Safety Evaluation Report

related to the final design approval
of the GESSAR II
BWR/6 Nuclear Island Design

Docket No. 50-447

General Electric Company

Figure 15.2 GESSAR II UPPS
Source: NEDE-30640

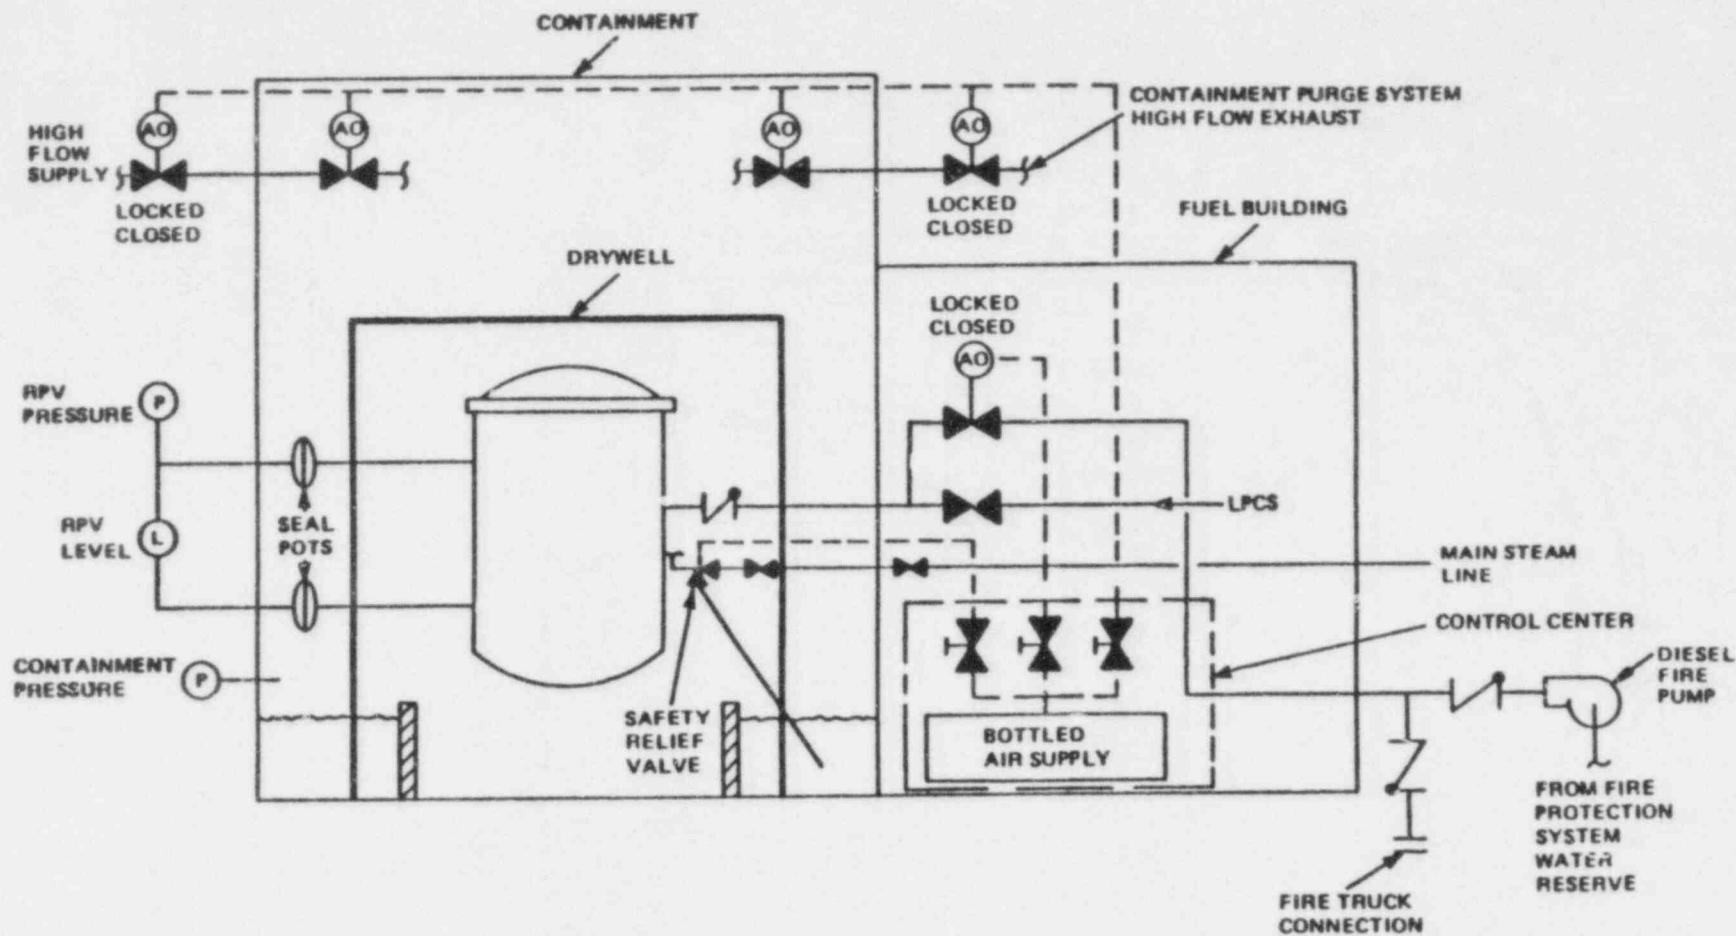
GE will provide detailed design information when an individual applicant references the GESSAR II design. Figure 15.2 shows a preliminary conceptual design of UPPS. The three primary functions of the UPPS are to (1) provide a reactor pressure vessel (RPV) makeup water supply capable of keeping the core covered, (2) provide RPV depressurization, and (3) provide containment heat removal. The system utilizes portions of the plant's emergency fire system, with modifications to allow for injection of water into the low-pressure core spray line. Dedicated air bottles will be used to provide motive power for air-operated injection valves, as well as operation of the safety/relief valves that must be used to depressurize the plant before injection from the low-pressure fire pumps. Air-operated containment vent valves will also be included to permit

After evaluating the potential design modifications, GE incorporated UPPS into the GESSAR II design. However, because of the preliminary nature of the design, the staff could not arrive at definitive assessments of the system's performance and capabilities. Conceptually the system offers significant advantages for responding to station blackout events, a class of accidents shown by the PRA to be a dominant contributor to core-melt frequency.

Although the UPPS system as proposed by GE has no seismic qualifications, the staff's PRA review indicated that seismic events dominate public risk. Without design details of the UPPS system, it was not possible to perform a detailed assessment of the system's seismic capabilities and response. However, the staff's contractor, BNL, in a draft report, "An Evaluation of Core Damage Reduction Benefits of Ultimate Plant Protection System" (Shiu and Reed, 1985), estimates the likely present seismic capability of the proposed UPPS. BNL modeled the core-melt reduction impact for upgrading the seismic capacity

From a defense-in-depth viewpoint, the staff also sees benefits to a seismically hardened UPPS even if the cost-benefit ratio is not shown to be attractive. The UPPS was proposed to be a final line of defense for the GESSAR II design. Very little plant equipment is required with this system to provide extended core cooling and containment heat removal. The staff evaluation of the GESSAR II PRA has shown that seismic core-melt risk exceeds the core-melt risk from internal events. Therefore, the proposed fall-back function of UPPS should show capabilities to respond to this class of event. However, the staff does affirm GE's design goal to maintain UPPS as a simple, manually initiated system of last resort.

The staff requires that GE provide details of how the modifications discussed in this section will be incorporated in the GESSAR II design. The staff requirements for these design improvements are conceptual in nature. In presenting the required detailed information on these systems, alternative designs may be proposed that offer equivalent functional performance. The staff requires that this information be submitted in sufficient time to complete its evaluation before issuing a construction permit or an operating license for a facility referencing the GESSAR II design. At this time, the staff does not believe that any design modifications in addition to those discussed and required above are warranted.
